**Ref:** SSD-89477725  
8 September 2026

**Proposal:** Three shop top housing buildings and one co-living building, totalling 866 dwellings including approximately 55 affordable housing dwellings to be provided in perpetuity

**Property:** 51-55 Parramatta Rd, 61 Parramatta Rd, 33 Queens Rd, 35-41 Queens Rd, and 43 Queens Rd, Five Dock

Council has reviewed the Environmental Impact Statement (EIS) and concurrent rezoning for State Significant Development (SSD) application SSD-89477725, and does not support the exhibited proposal for the reasons outlined in this letter.

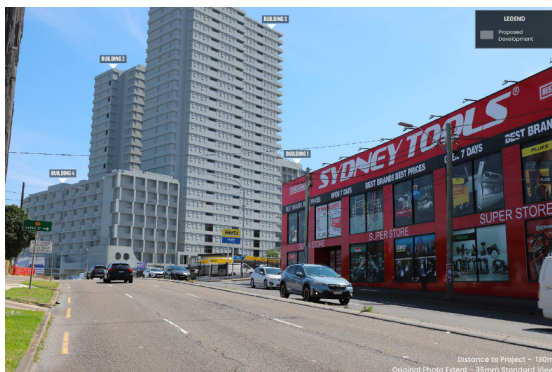
- Building 1 site separation and setback distance to the neighboring development does not meet the required ADG 12m separation.
- The proposed 22m strip of land (TOGA land) which sits outside of the new proposed north-south road and proposed site boundary (said to facilitate 'orderly development to the east when consolidated with existing dwellings fronting Courland Street') replaces the DCP nominated 12m deep soil zone between the rear boundary of existing dwellings on Courland Street and the development. This poses a risk for potential future sale of the land for development and subsequent loss of the nominated deep soil zone.

- Revise the building layout to comply with ADG separation requirements.
- Reduce extent of basement carpark and adjust boundary to allow for integration of a 12m deep soil zone within the streetscape of the new dedicated access road, or alternatively adjust the site boundary to accommodate a 12m deep soil zone to the east of the new road.

129-153 Parramatta Rd. Kings Bay Village 79-81 Queens Road

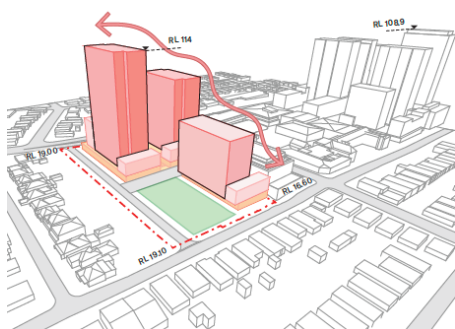
- Reduce the south facing 8 storey residential podium and street wall fronting Parramatta Road to a 4 storey street wall to reduce the visual dominance and to be in line with the proposed 4 storey street wall as nominated within the Kings Bay precinct DCP controls, and to be distinctively lower in scale to Kings Bay Village development in the proximate MU1 precinct.
- Retain the 8 storey residential podium and street wall at the corners of Building 4 whilst reducing the central portion to 4 storeys emphasizing the corners of the buildings as visual anchors and gateways to the development, referring to language within the primate Kings Bay Village Development.

Proposed Heights

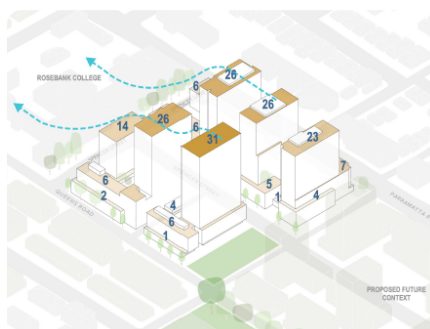
- Use the 14 storey west facing building in Kings Bay Village as the datum line for buildings within the development considering its peripheral location within the Kings Bay Precinct.
- Adjust heights of all towers in the development to remain in the order of 8-14 storeys in keeping with the proposed 14 storey datum line providing an appropriate transition to the existing low density residential character whilst capitalizing on views, park frontage, and minimizing overshadowing.

Parramatta Road Interface looking west

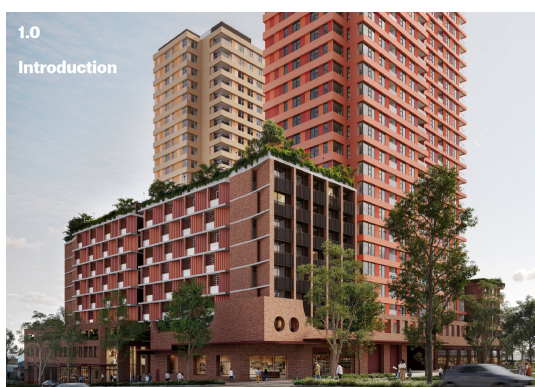
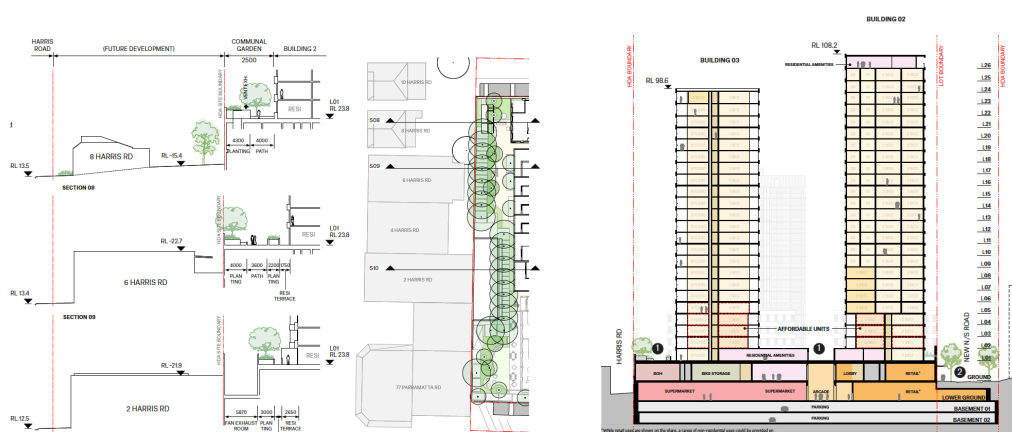
- The western facades of Buildings 2 and 3 appear as a flat, largely unarticulated wall of development contributing to a bulk and scale that is not in keeping with the low-density residential neighborhood character to the east of the development that is zoned to remain as R2.

- Consider additional horizontal and vertical articulation of the longer facades of buildings 2 and 3 to break up the mass of the building into smaller sized vertical forms. Additionally consider extending the 4 storey podium treatment recommended for Building 4 along half the eastern face of Building 3 to further break up the vertical massing.

- Introduce multiple and larger breaks in the facade of Building 4 to break up the mass of the building into smaller sized vertical forms.
- Apply a consistent design language of geometry, rhythm and proportion to the southern, western and eastern facades of Building 4, that builds on the architectural expression of the southern facade in keeping with the deep rooted urban and cultural narratives, to create a balanced composition and maintain coherence whilst responding to varying edge conditions.

## 8. Landuse Mix and Distribution

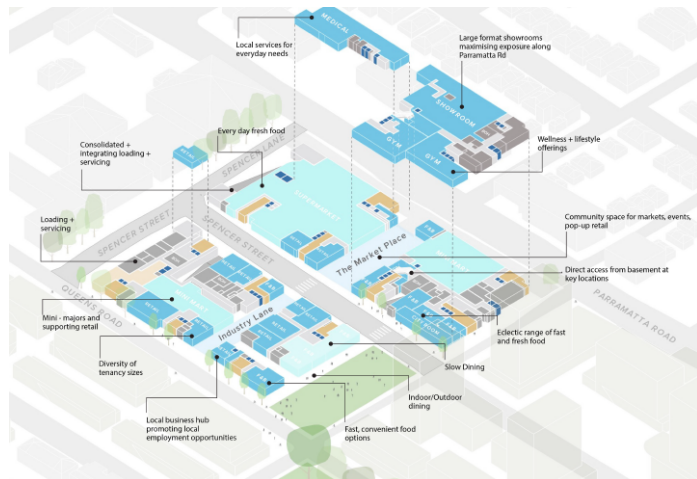
- Large format retail is not supported at this site based on the sites R3 zoning and proximity to other sites in the MU1 zone which are required to provide for non-residential floorspace at ground level and are currently proposing large format supermarkets, showroom and retail spaces. Proposed large format retail provision runs the risk of undermining the strategic intent of establishing Kings Bay Village as a mixed use centre and drawing activity away from the heart of the Kings Bay precinct and creating empty and unleaseable retail floorspace.

- Reduce scale of retail provision and associated car parking to provide opportunity for additional publicly accessible communal open space at ground within the southern portion of the development to be activated by and connect to the north-south pedestrian/cycle link and serve residents and community alike, contributing to wider the open space network of the wider area.
